Reference: Under The Steps – Access Report
Development Application

**UNDER THE STEPS
SYDNEY OPERA HOUSE**

Project: Sydney Opera House
Under The Steps
Document Type: Access Report – Development Application
Report Number: IAC-333

Figure 2 Under The Steps - Plan

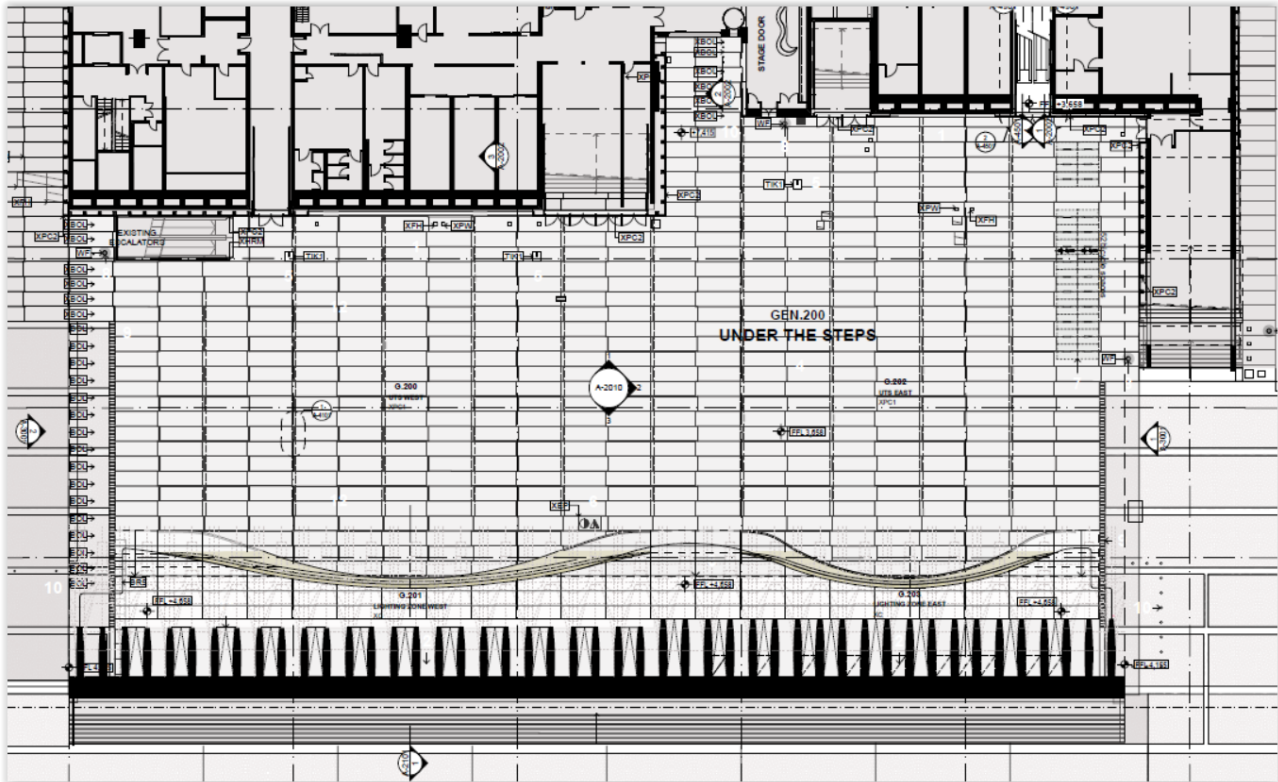
The main access related issues relate to the following:

- The detailing of the paving materials
- Wayfinding and signage
- Lighting levels
